**List of Attachments for Item No. 1**  
**1980 Tarob Court Residential Project**

**A RESOLUTION OF THE CITY COUNCIL OF THE CITY OF MILPITAS APPROVING MAJOR VESTING TENTATIVE MAP NO. MT15-0013, CONDITIONAL USE PERMIT NO. UP15-0020, SITE DEVELOPMENT PERMIT NO. SD15-0015, AND ENVIRONMENTAL ASSESSMENT NO. EA16-0003 FOR THE CONSTRUCTION OF 59 TOWNHOME UNITS AND ASSOCIATED SITE IMPROVEMENTS ON 2.81 ACRES LOCATED AT 1980 TAROB COURT**

PRELIMINARY GRADING DRAINAGE PLAN  
TM04

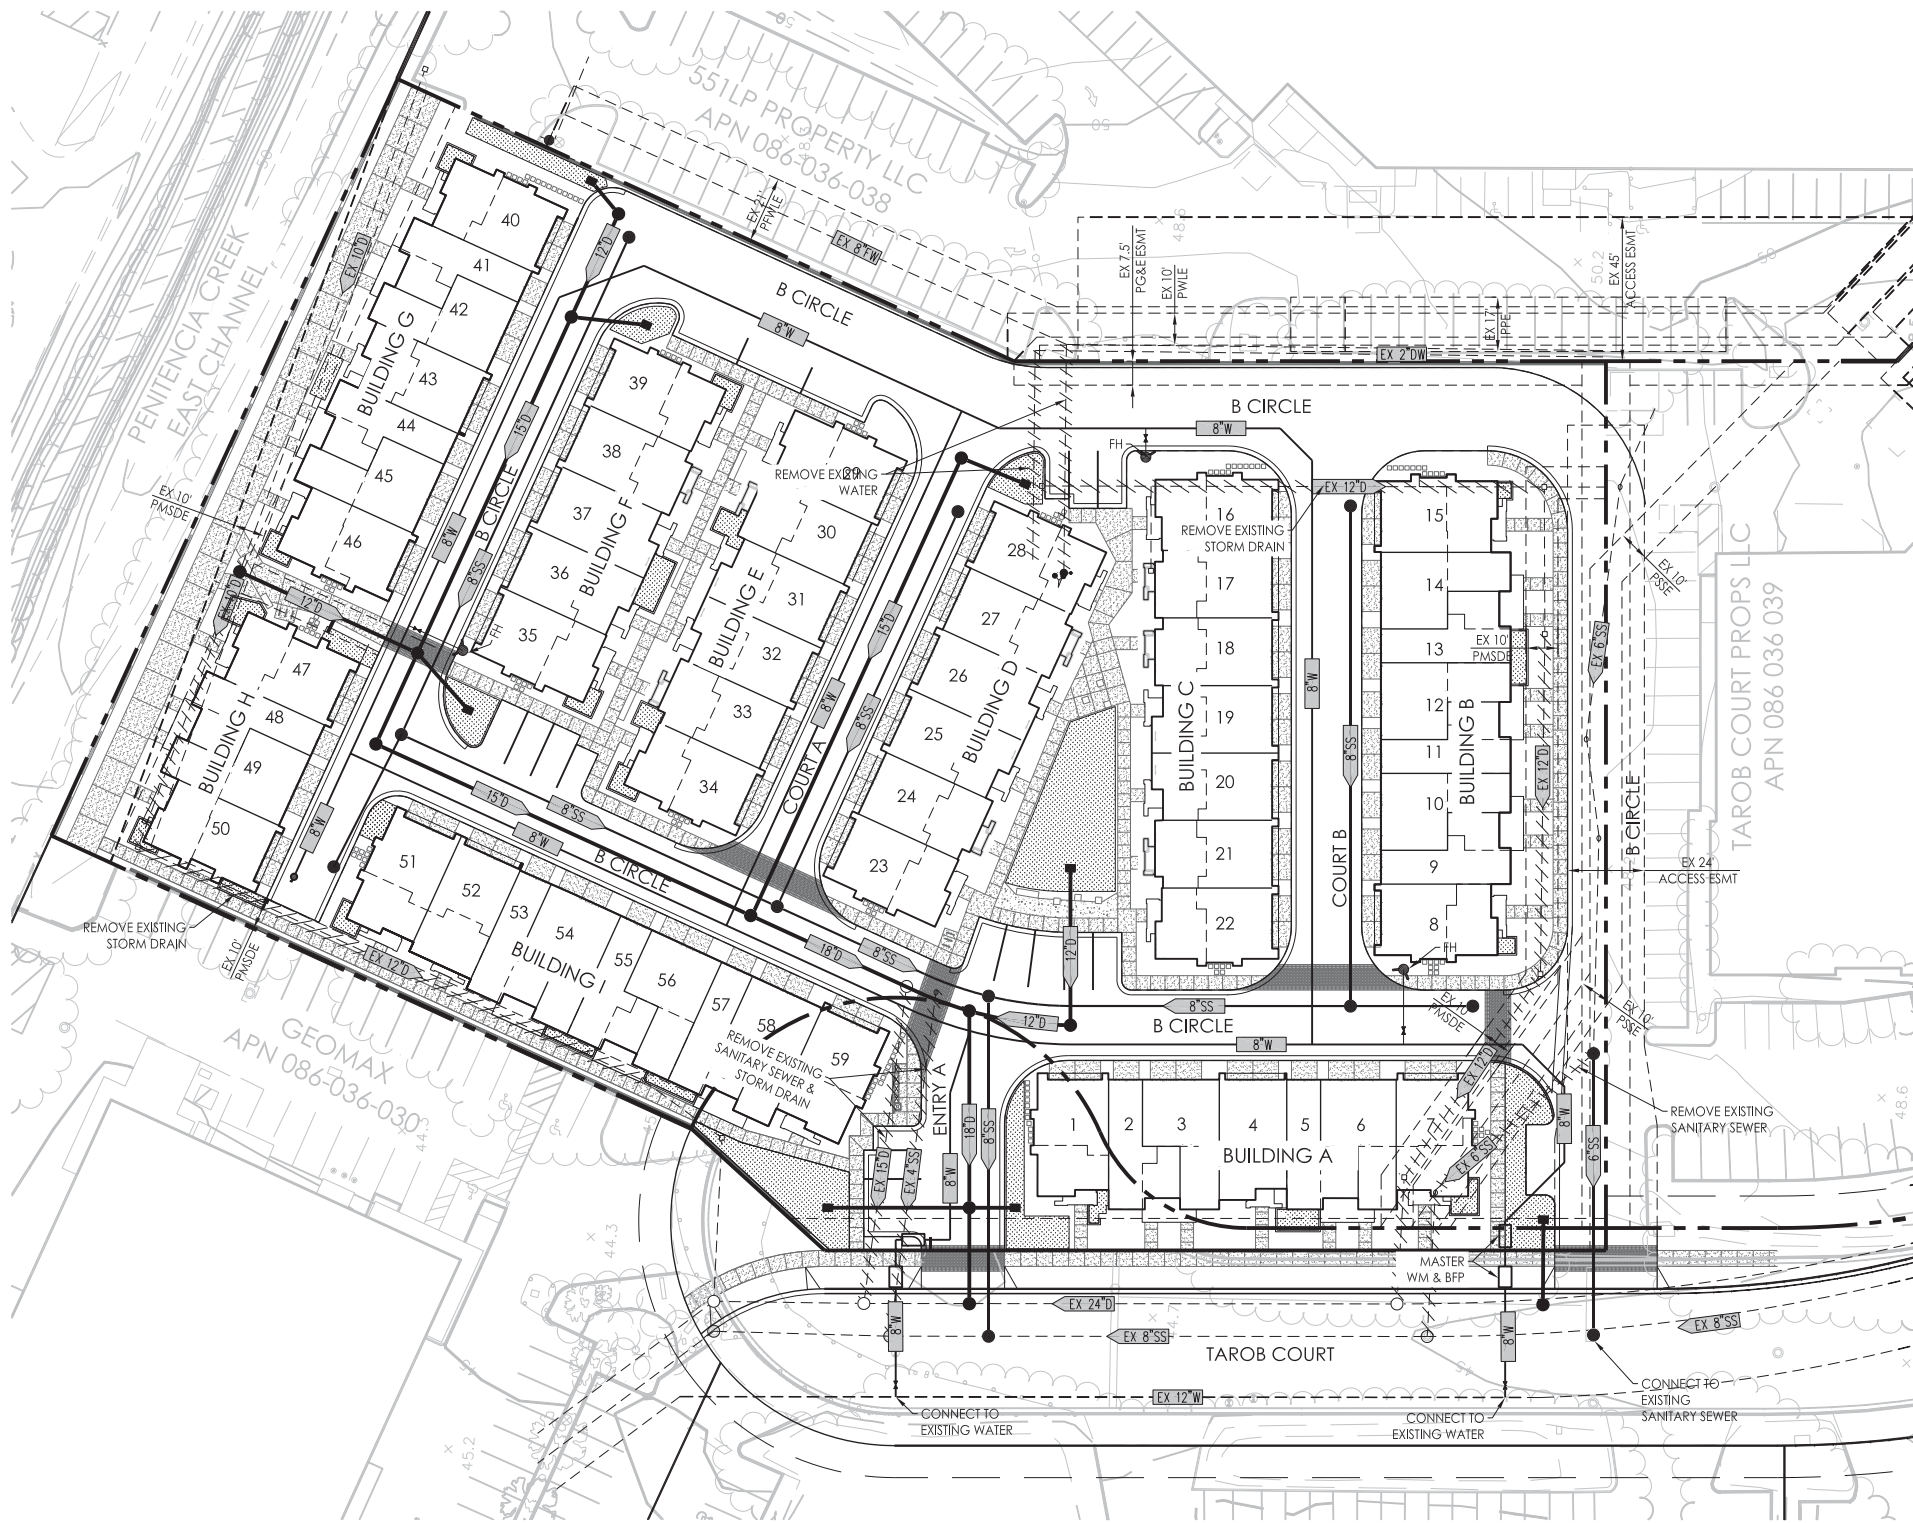
Sheet C4.0 Preliminary Grading Drainage Plan: Please clarify who will be responsible for the retaining wall. In general, the retaining wall should also be set back from the property line to allow for maintenance (repairs, graffiti removal, etc,...) by the HOA/City without having to enter the District's property.

### Section AA

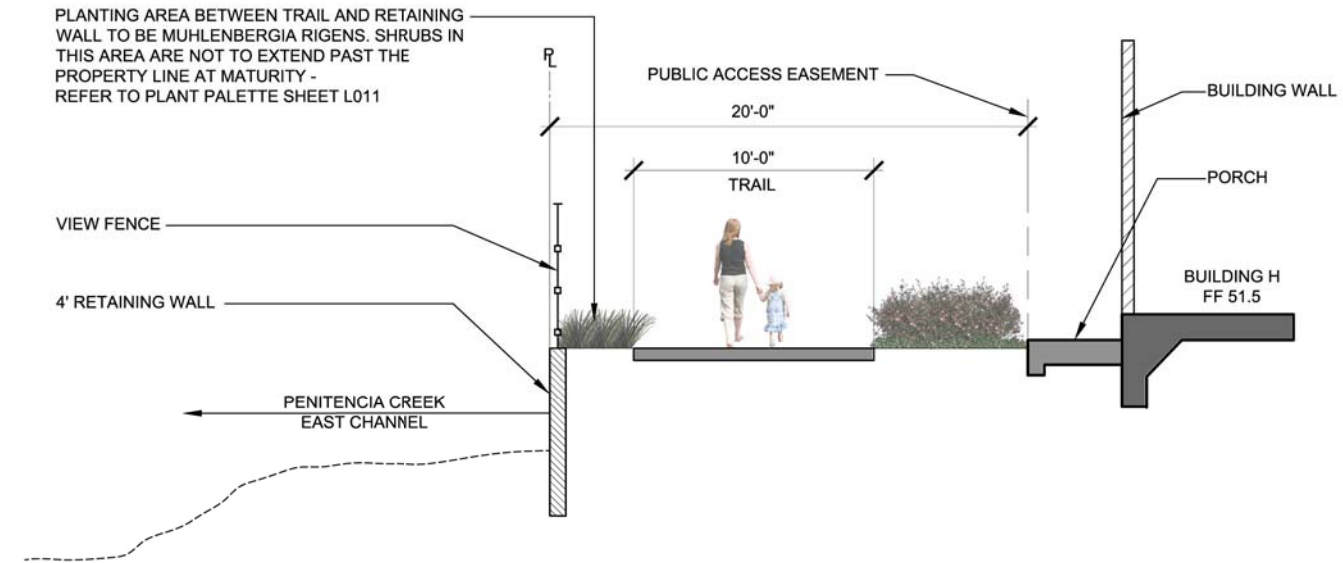
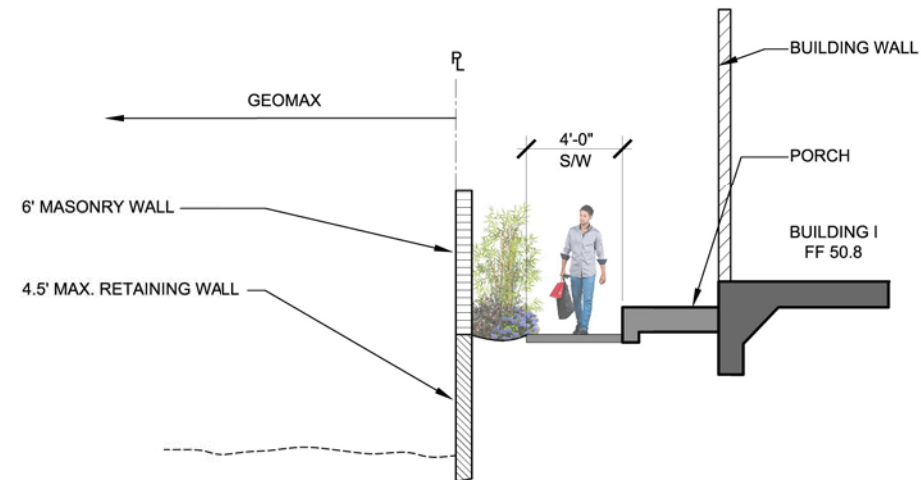
Sheet L002: Section AA shows the retaining wall within the District's right of way. The retaining wall, including its footing, must be located outside the District's property.
